August 28, 2001

**Re: GE-Pittsfield/Housatonic River Site  
30s Complex (GEC120)  
Supplemental Information for the June 2001 *Demolition/Consolidation Work Plan for  
Buildings 31, 31-J, and 31-P***

**MONITORING WELL LOCATIONS**

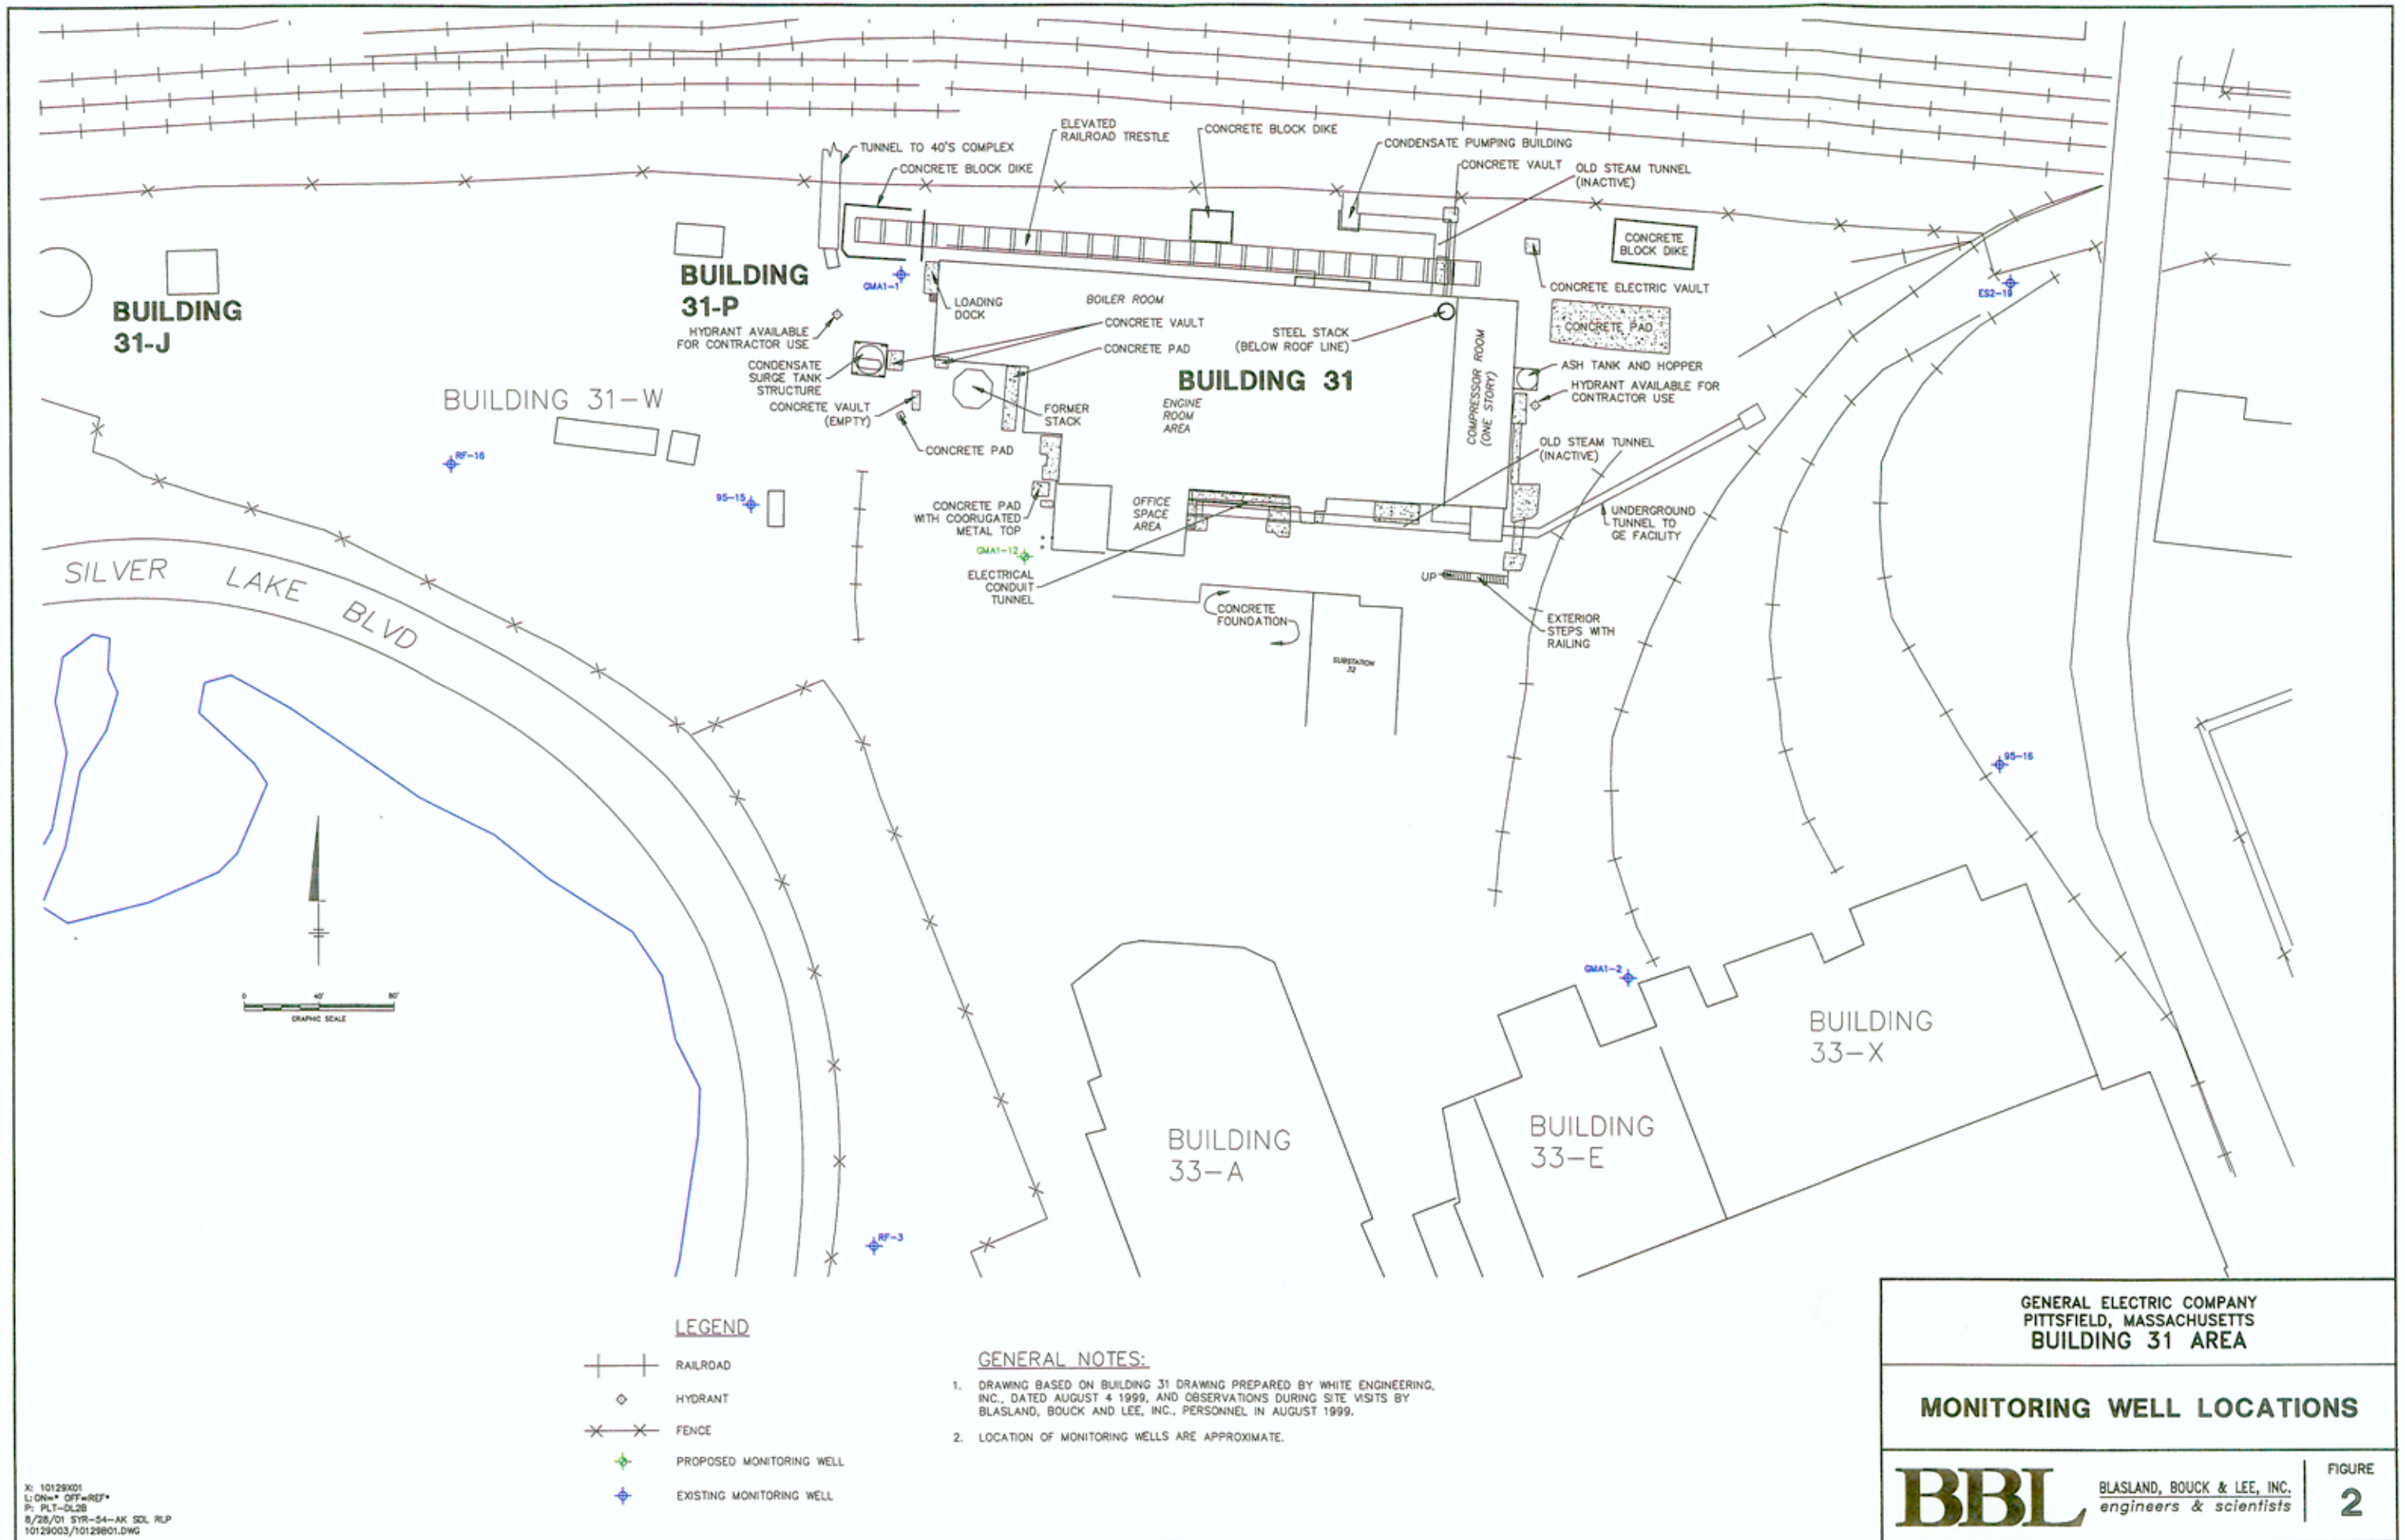
During the August 15<sup>th</sup> meeting and site visit, EPA acknowledged GE's language in the Work Plan regarding the potential for future interaction between local groundwater and the demolition materials consolidated within the Building 31 basement. EPA inquired as to the elevation of the Building 31 basement floor relative to the historical seasonal high groundwater levels in the area of Building 31.

GE also conducted water level measurements at seven watertable monitoring wells in the vicinity of the Building 31 Complex on August 17, 2001, to supplement the data collected from groundwater monitoring performed in Spring 2001. The well locations are illustrated on Figure 1 in Attachment D and corresponding water elevations measured in August 2001 are provided in Table 1 in Attachment D. In addition, GE has reviewed the historical seasonal high (spring) water elevation measurements from these wells, which in most cases date back to 1996. These data are presented in Table 2 in Attachment D.

Of these wells, the well that is closest to and thus most representative of groundwater conditions beneath Building 31 is well GMA1-1, located adjacent to the northwest corner of Building 31. Following installation of this well in Spring 2001 (as part of the GMA 1 well installation program), the measured seasonal high (spring) groundwater elevation was 979.43 feet amsl, which is more than a foot lower than the lowest elevation of the Building 31 basement floor. However, since this well was only recently installed, historical water level data do not exist for this location. As a result, GE has reviewed the historical seasonal high groundwater elevation data from the other wells in this vicinity for which such data do exist (five wells) (as shown in Table 2) to determine whether the Spring 2001 data are representative of the seasonal high water table. As indicated in Table 2, the Spring 2001 groundwater elevations for these wells are sometimes slightly higher and sometimes slightly lower than the maximum previously recorded spring groundwater elevations. On average, for these five wells, the Spring 2001 elevations are only approximately 0.62 feet lower than the maximum previously recorded elevations. Accordingly, to estimate the maximum seasonal high groundwater elevation at well GMA1-1, that difference was added to the Spring 2001 groundwater elevation for well GMA1-1 (979.43 feet amsl), which yields an estimated high groundwater elevation of approximately 980.05 feet amsl.
